Safety Evaluation Report

Related to the License Renewal of the Millstone Power Station, Units 2 and 3

Docket Nos. 50-336 and 50-423

Dominion Nuclear Connecticut, Inc.

Figure A: Trend Line Relationship with Horizontal Tendons

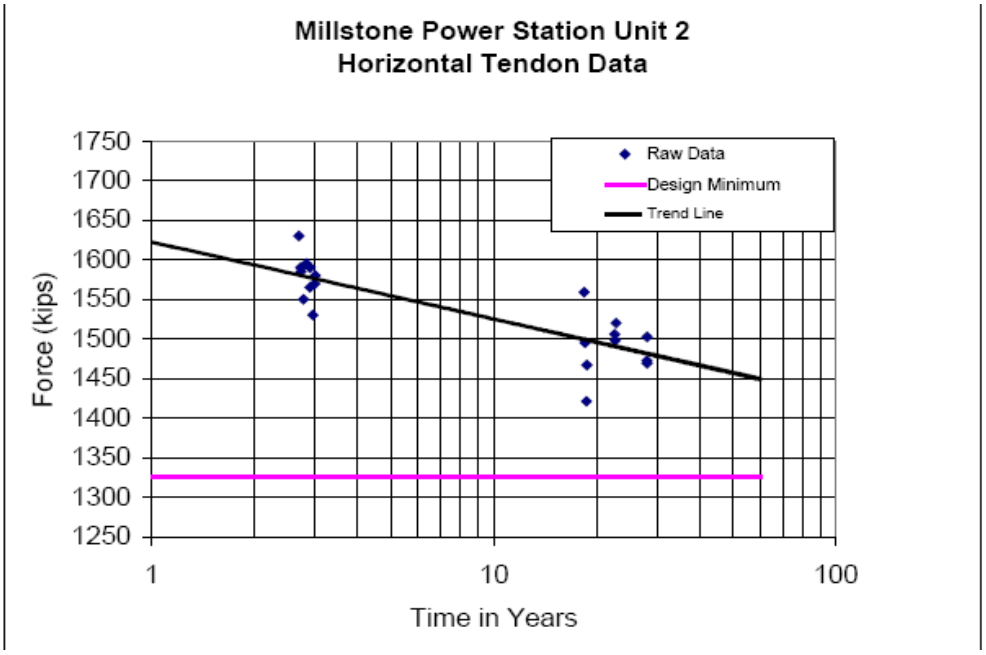
In RAI 4.5-5, the staff noted that the process used by license renewal applicants with respect to prestressed concrete containments is to assume that the tendon force varies with the logarithm of time (as discussed in RG 1.35.1). The staff indicated that it was not apparent in Figure 4.5-1 what functional relationship had been assumed between the two variables. The applicant was requested to provide additional information regarding the process used in arriving at the trending curves shown in Figure 4.5-1.

In its response, in a letter dated January 11, 2005, the applicant confirmed that it is using procedures for monitoring and trending prestressing force consistent with the recommendations in RG 1.35.1 and NRC Information Notice 99-10. Therefore, the staff finds the process acceptable, as the use of RG 1.35.1 for estimating the target prestressing forces, and Information Notice 99-10 for projecting the actual measured prestressing forces (as illustrated in the figure above), provides the elements needed for an adequate TLAA.
